ADDENDUM

Project: Science Building Research Wing Expansion

Project No. 03049

Addendum: No. 1

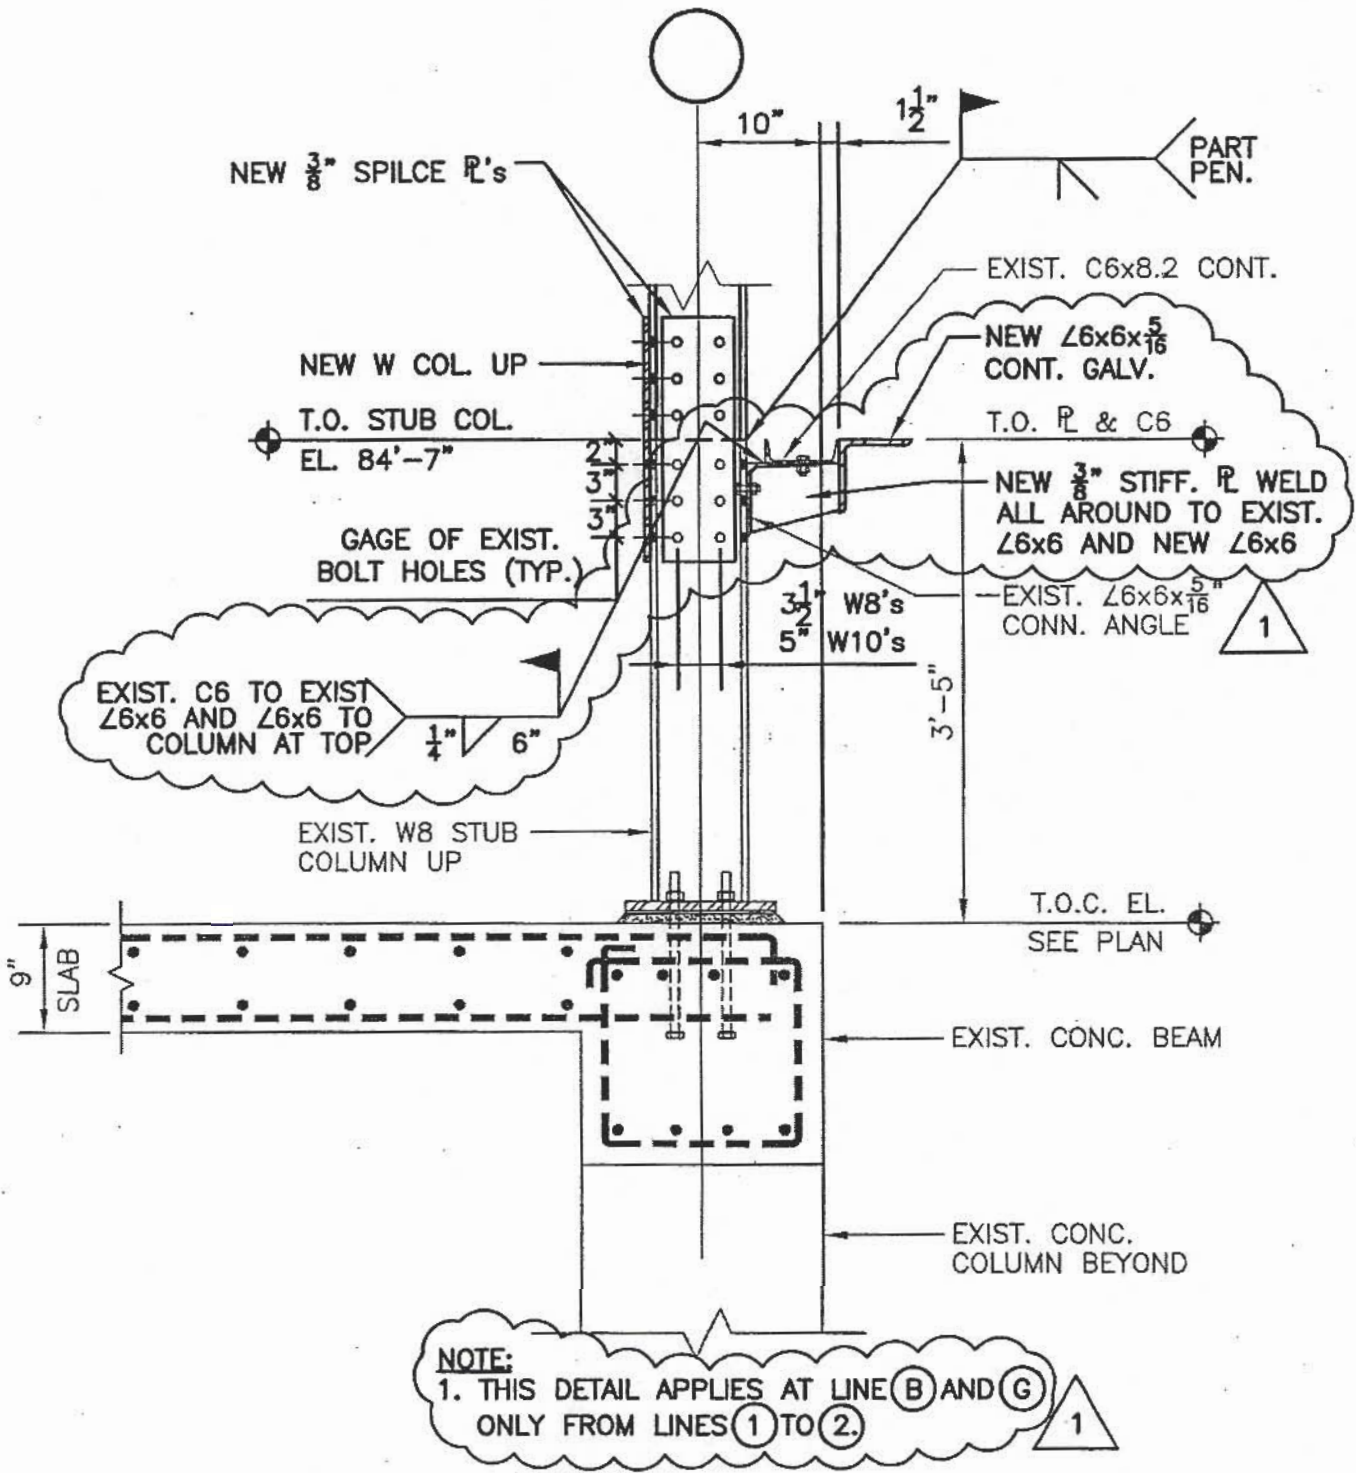
1. Add new Section 2a as shown on sketch ADD-1/SKS-7.
2. Add new Section 20a as shown on sketch ADD-1/SKS-8.

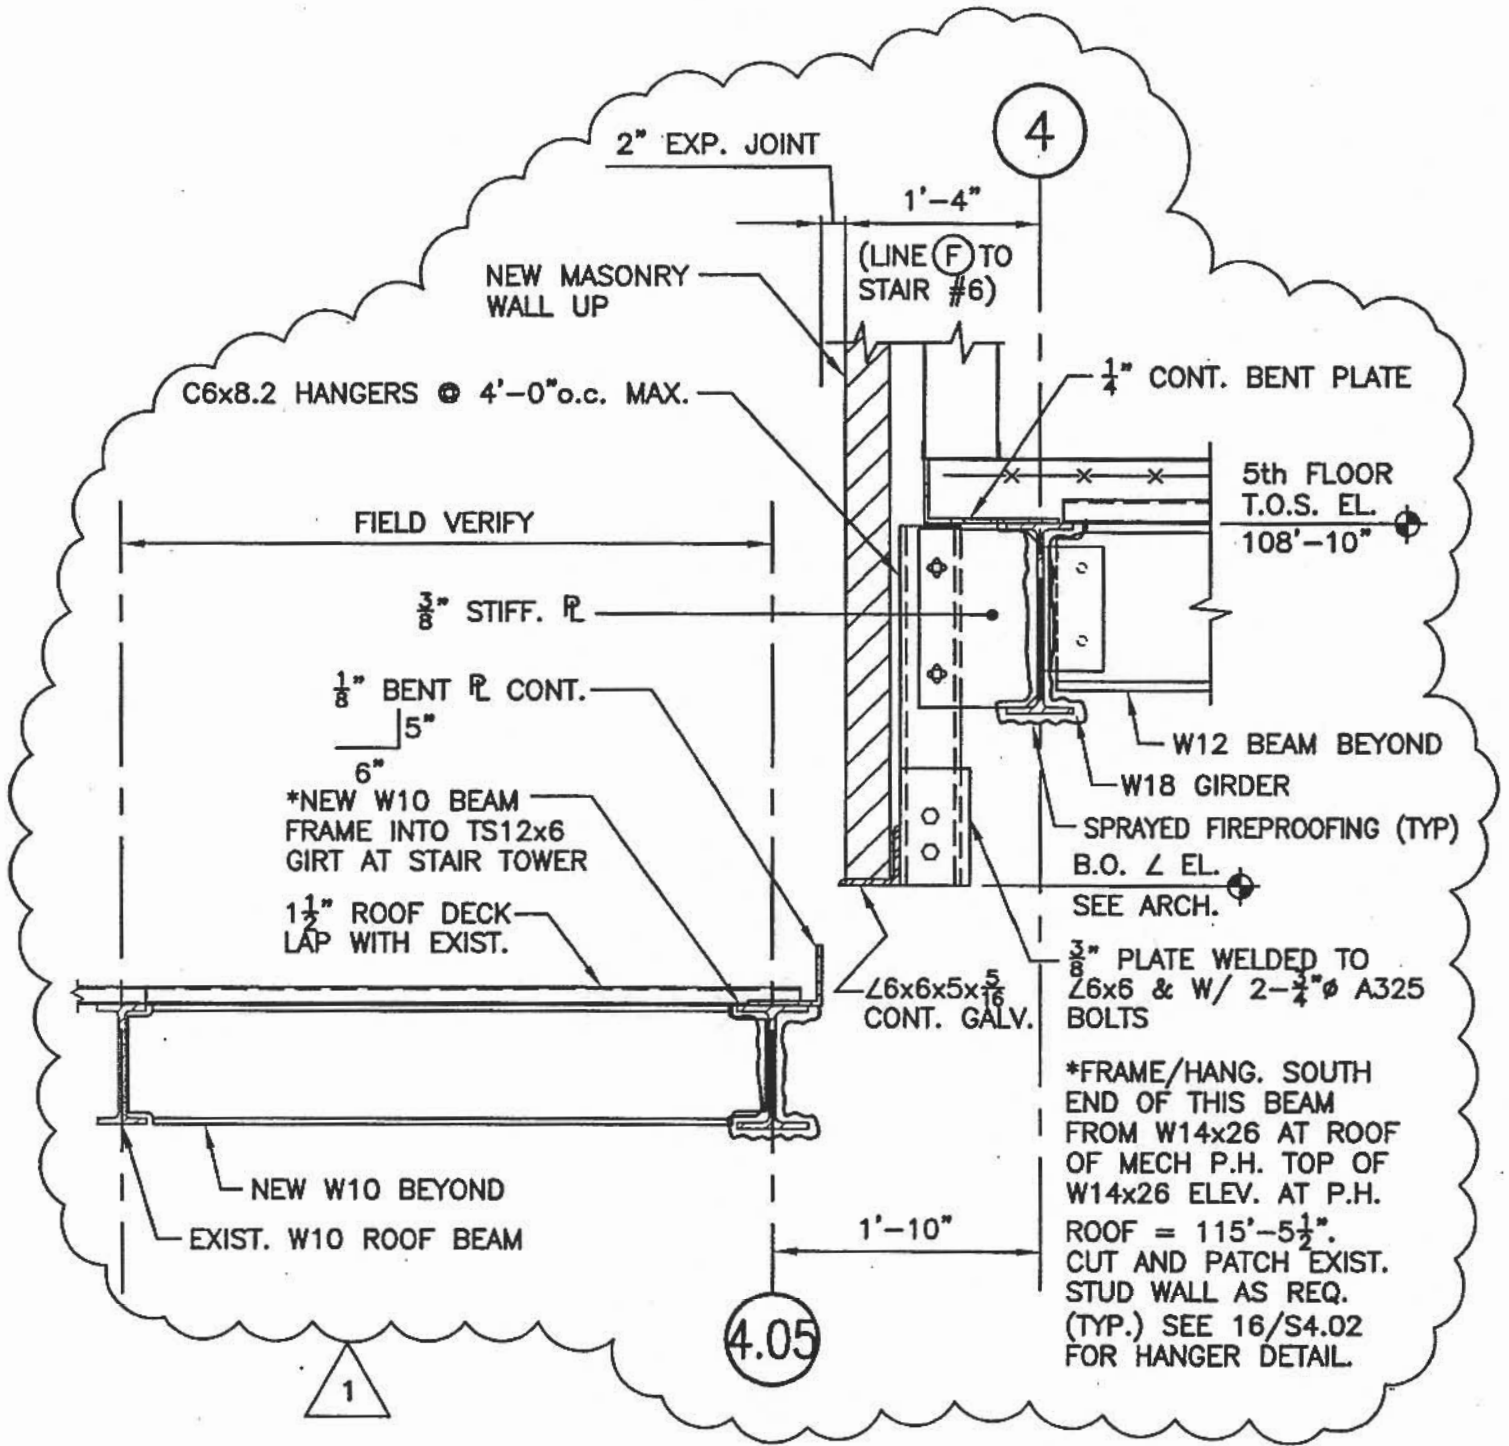
1. Revise Section 13 as shown on sketch ADD-1/SKS-9.
2. In Sections 11 and 12 make the top of steel elevation at the stair landing equal to 123'-7".

<p>Symmes, Maini & McKee Associates 1000 Massachusetts Avenue Cambridge, MA 02138</p>	<p align="center">UNIVERSITY OF SOUTHERN MAINE PORTLAND, MAINE</p>	DATE	04/28/04	SKE-02
		SCALE	1/8"=1'-0"	
THIRD FLOOR POWER & LIGHTING REVISION		DR. BY	CK. BY	JOB NO.
		CDN	SD	03049.00

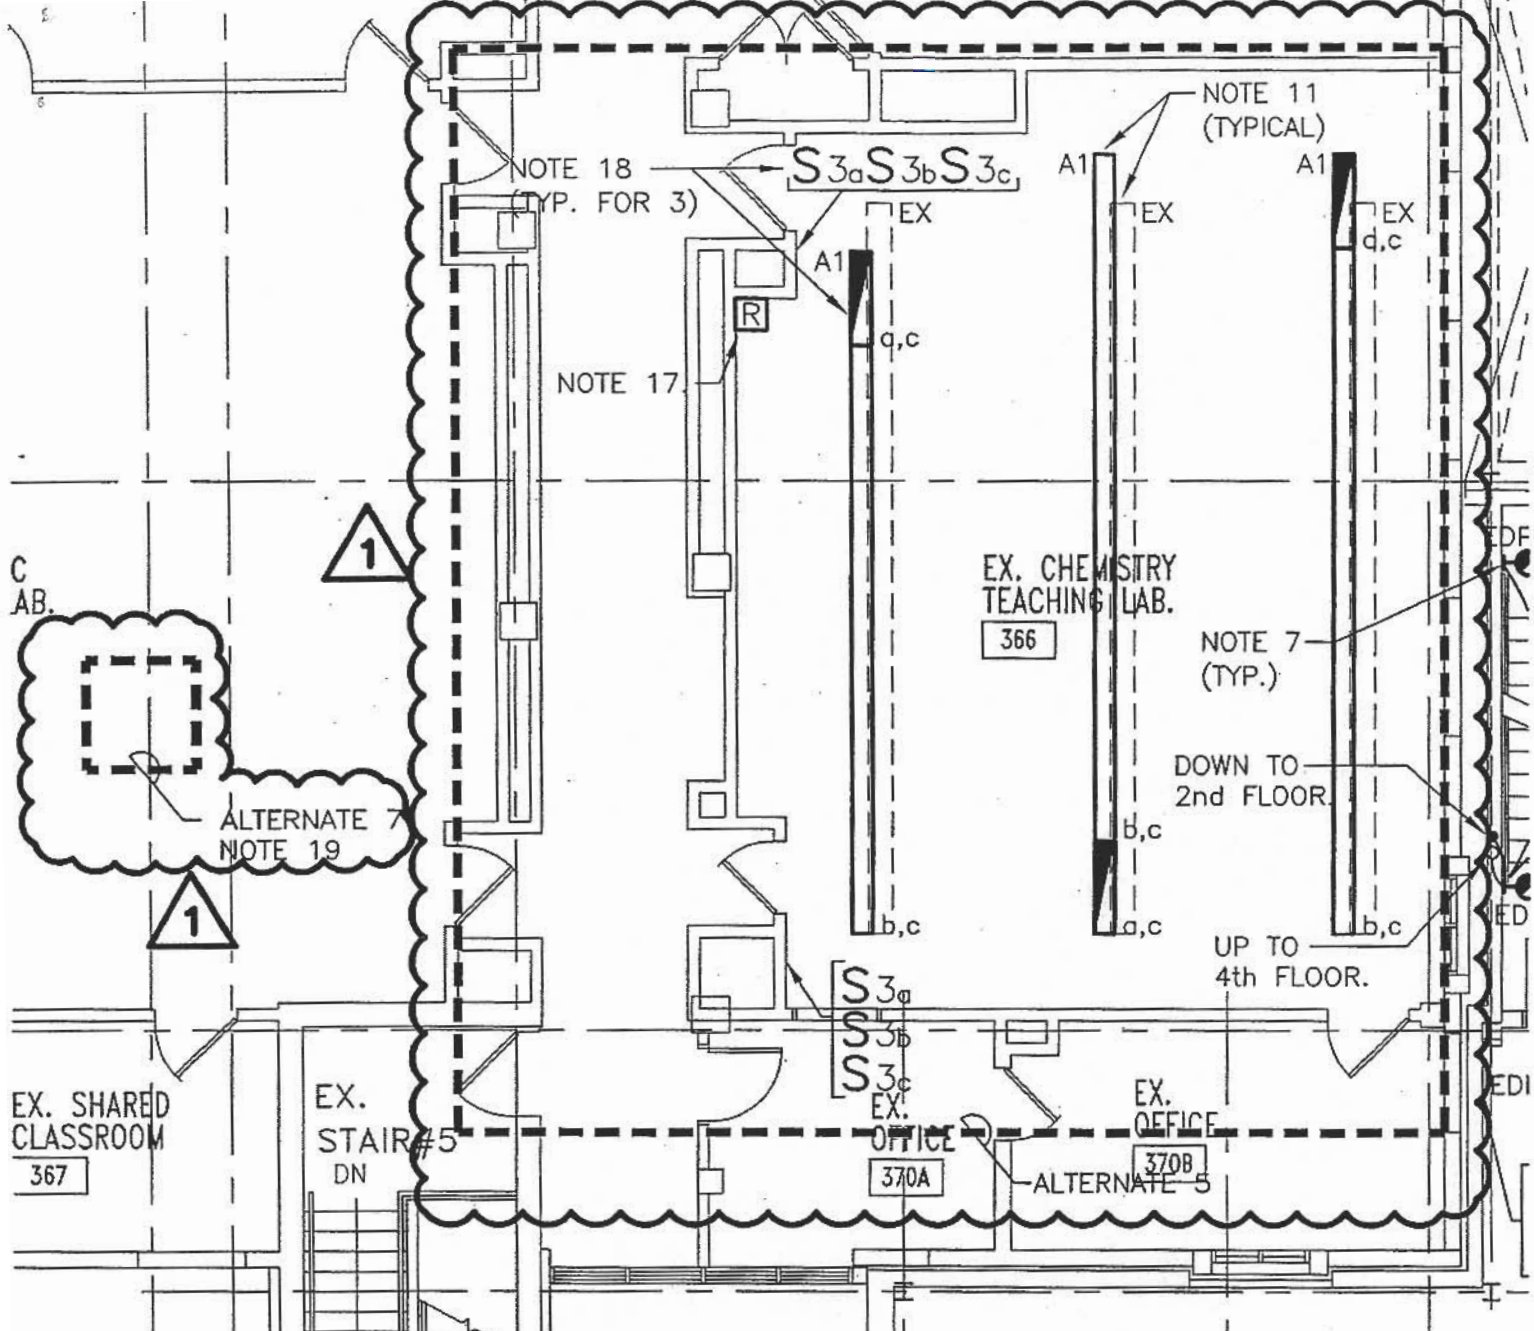
1. Make changes shown on SKE-02 and SKE-03.

11. DUE TO CEILING LOWERING IN THIS ROOM, EXISTING LIGHTING FIXTURES SHALL BE DISCONNECTED AND REMOVED. NEW LIGHTS TYPE "A1" SHALL BE WIRED TO EXISTING LIGHTING CIRCUIT. PROVIDE NEW SWITCHING ARRANGEMENT AS INDICATED. SWITCHES "a" & "b" CONTROL ALL OUTER LAMPS, SWITCH "c" CONTROLS ALL INNER LAMPS. 1

Symmes, Maini & McKee Associates 1000 Massachusetts Avenue Cambridge, MA 02138	UNIVERSITY OF SOUTHERN MAINE PORTLAND, MAINE		DATE 04/28/04	SKE-03
			SCALE 1/8"=1'-0"	
	FOURTH FLOOR POWER & LIGHTING REVISION		DR. BY CDN	CK. BY SD

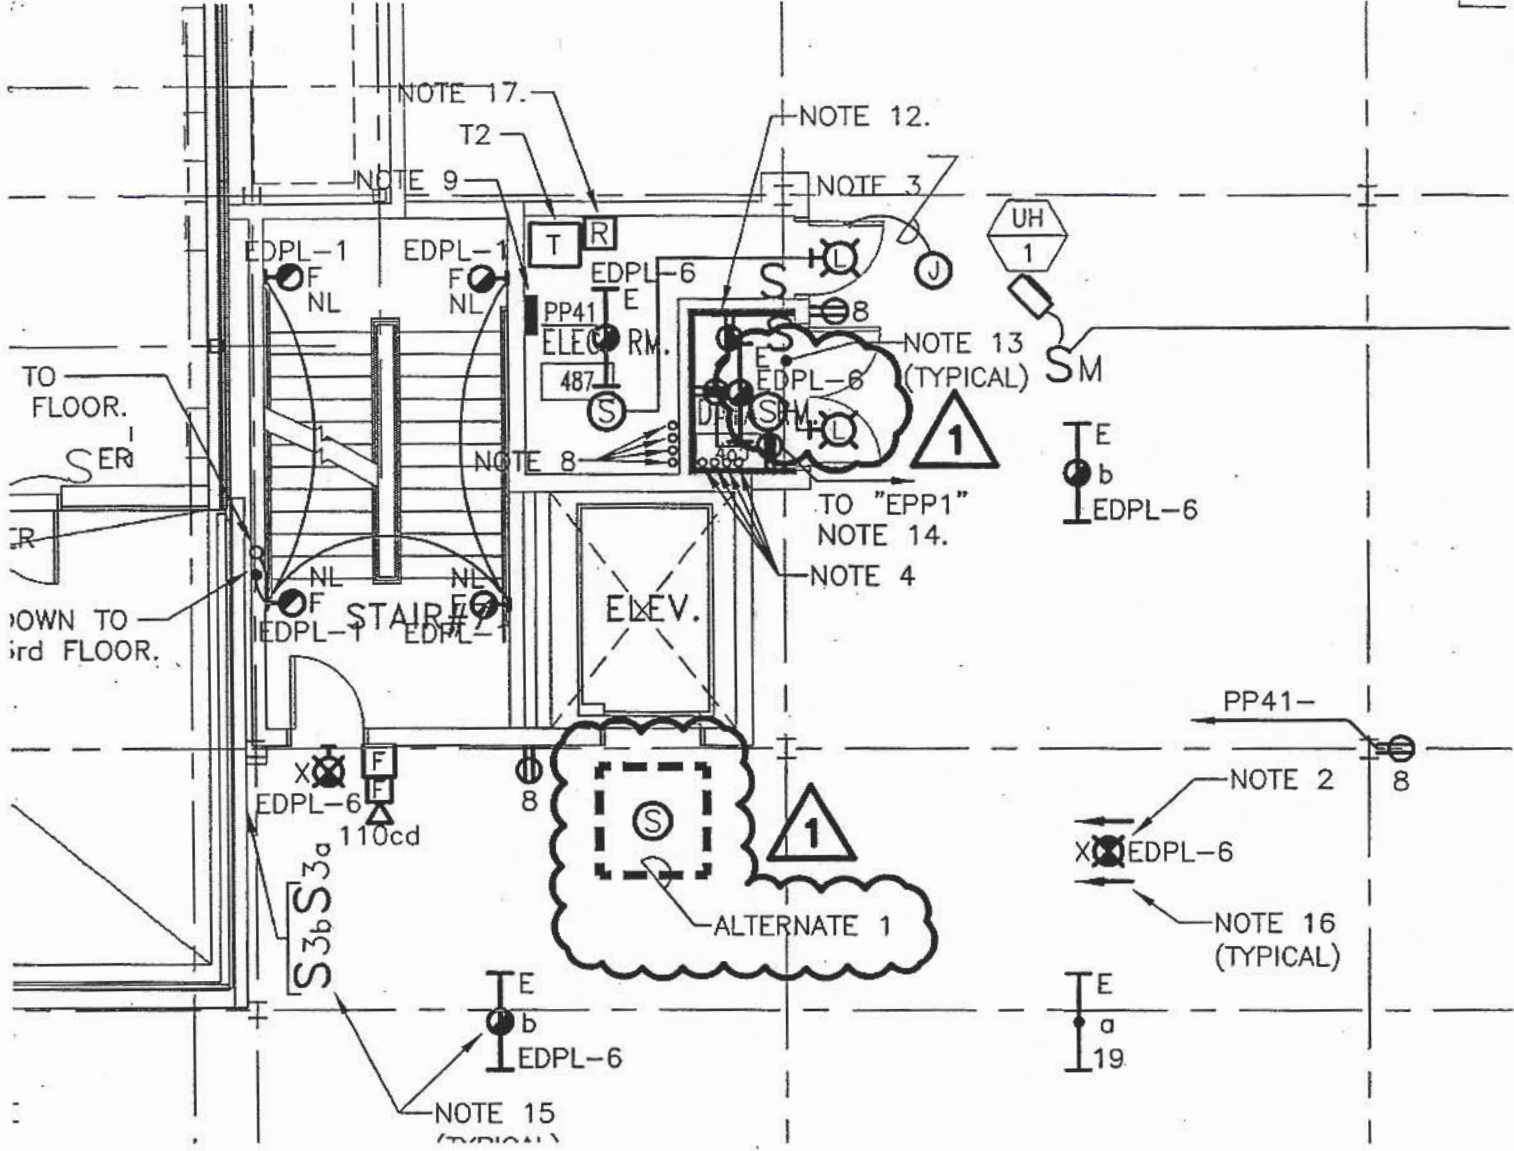
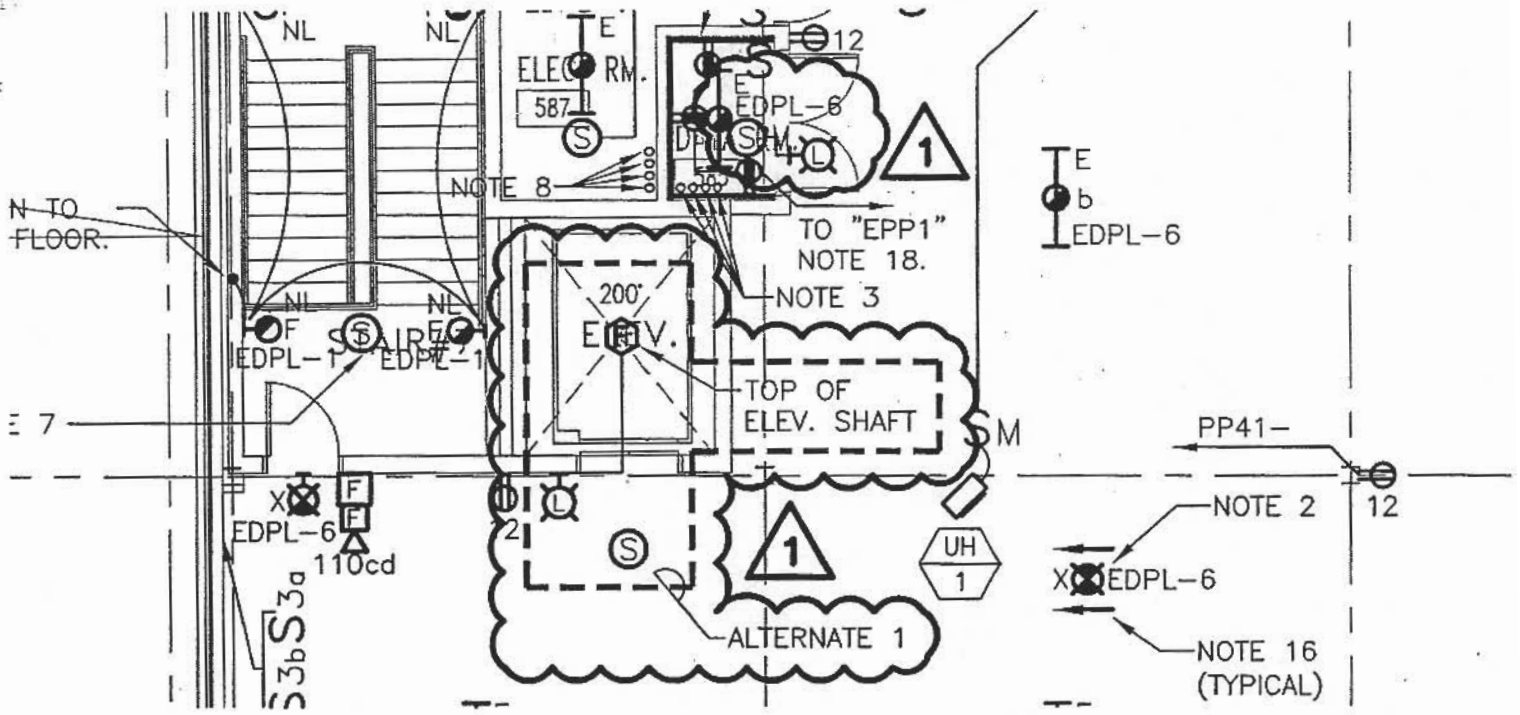
19. ALTERNATE 7 SCOPE OF WORK CONSISTS OF: DUE TO EXTERIOR WALL RENOVATION DISCONNECT EXISTING ROOF-MOUNTED CONDENSING UNIT (LOCATED AT INTERSECTION OF GRIDS C AND 10, REFER TO ARCHITECTURAL ELEVATION DETAIL A3/2.2), RE-INSTALL ASSOCIATED EXISTING EXTERIOR DISCONNECT SWITCH AND RE-CONNECT CONDENSING UNIT. 1

Symmes, Maini & McKee Associates 1000 Massachusetts Avenue Cambridge, MA 02138	UNIVERSITY OF SOUTHERN MAINE PORTLAND, MAINE	DATE	04/28/04	SKE-04
		SCALE	1/8"=1'-0"	
FIFTH FLOOR AND ROOF PLAN POWER & LIGHTING REVISION		DR. BY	CK. BY	JOB NO.
		CDN	SD	03049.00

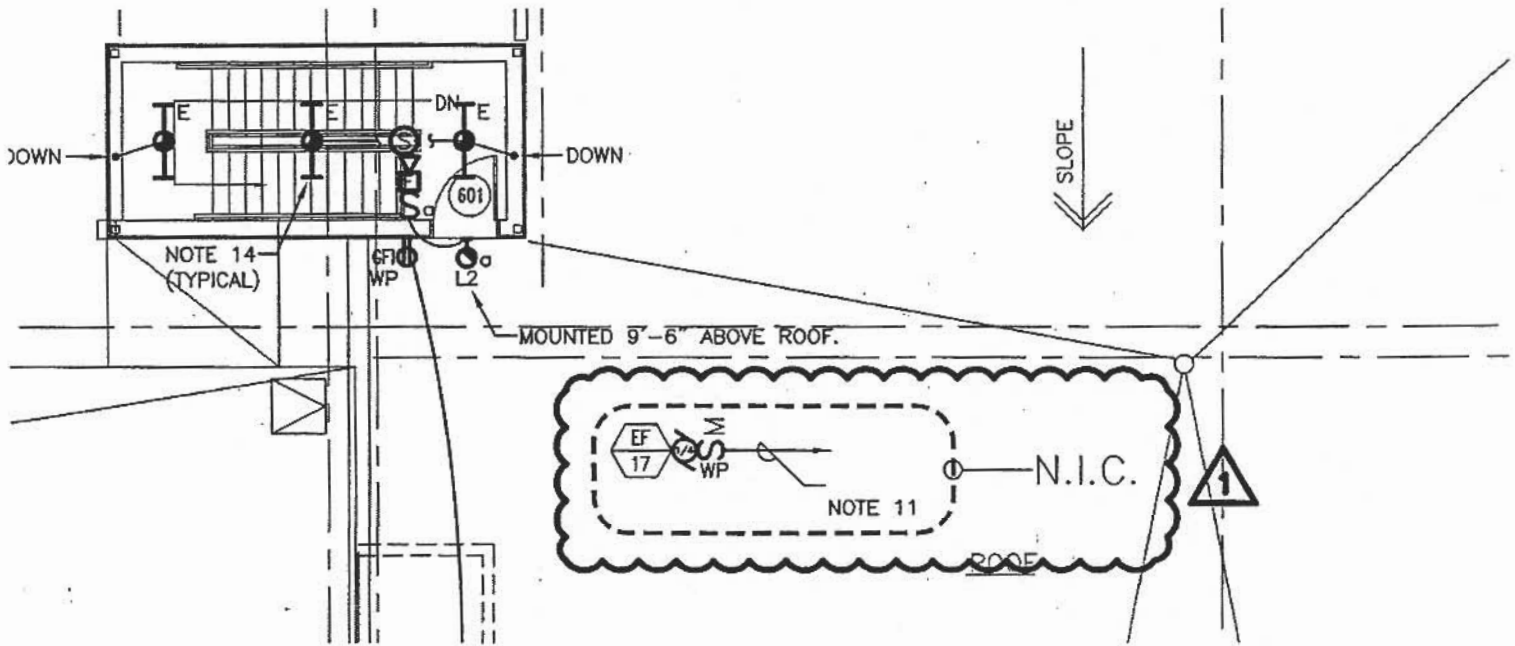
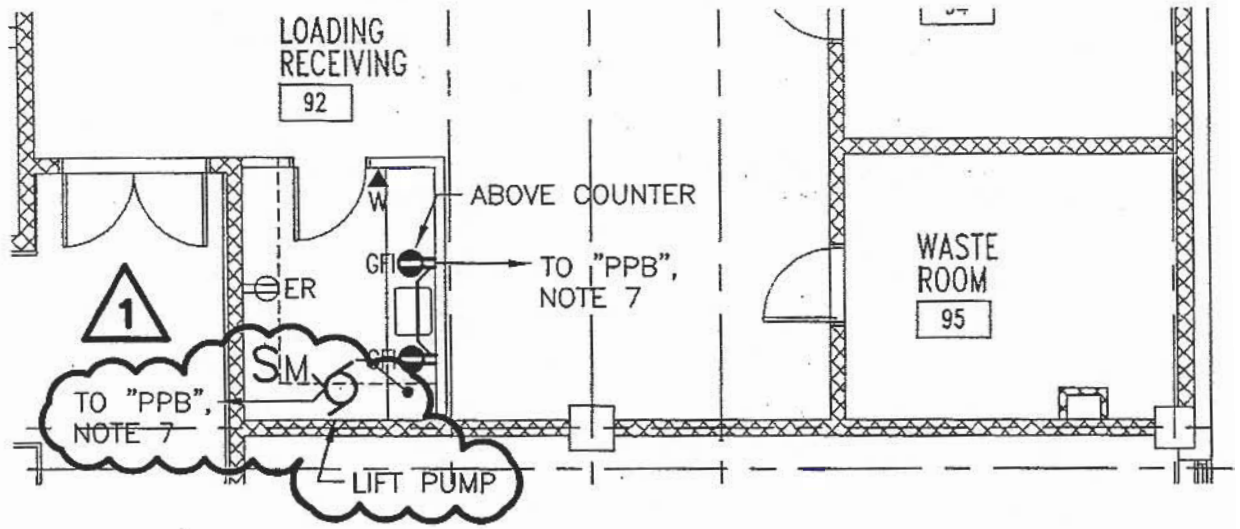
1. Make changes shown on SKE-04.
